09 - 2011
BTD141, BTD141Z, BTD141H2
18V IMPACT DRIVER KIT

SERVICE CHANGES

1. Changes on Hammer Case Cover and Bumper

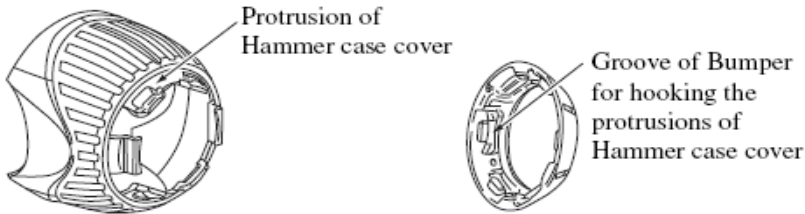
Item No.	Description	Type 1	Type 2
14	Bumper	424015-7	424369-2
15	Hammer Case Cover	450585-0	452409-6

Above parts are completely interchangeable as a set.

Type1: Bumper is hooked with the grooves of Hammer case.

Type2: Bumper is hooked with the protrusions of Hammer case cover as illustrated below.

2. Changes How to Assemble Carbon Brushes

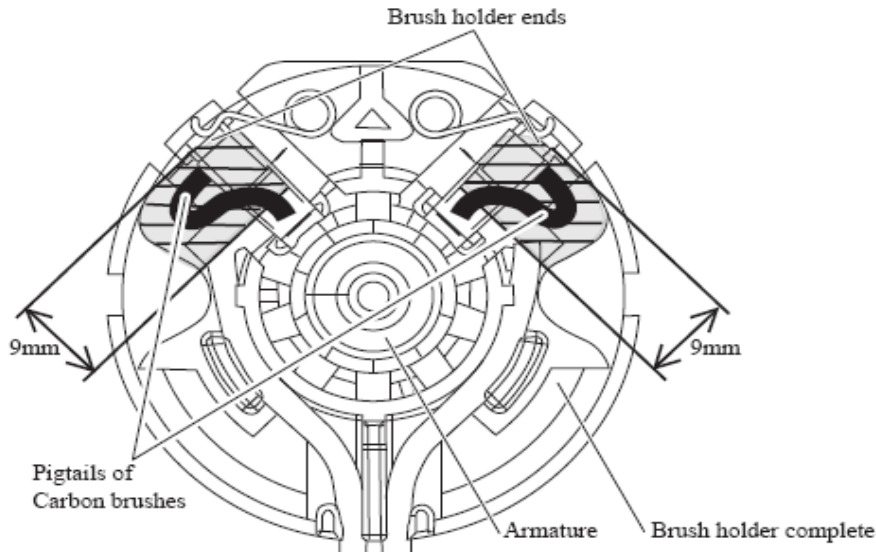
Item No.	Description	Type 1	Type 2
36	Carbon Brush	194427-5 (W/O ORIGIN)	195021-6 (W/ ORIGIN)

Do not protrude the pigtails of Carbon brushes from the specific spaces.
Refer to the following illustration.

3. Changes on Hook

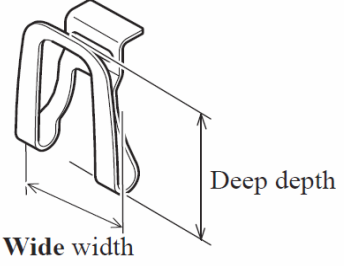
Item No.	Description	Type 1	Type 2
A05	HOOK	324705-1	346449-3
A05	HOOK	346034-2	346449-3

Width has been changed wide size to narrow size

Type 1	Type 2
 <p>Wide width (324705-1)</p>	 <p>Narrow width (346449-3)</p>
 <p>Wide width (346034-2)</p>	 <p>Narrow width (346449-3)</p>
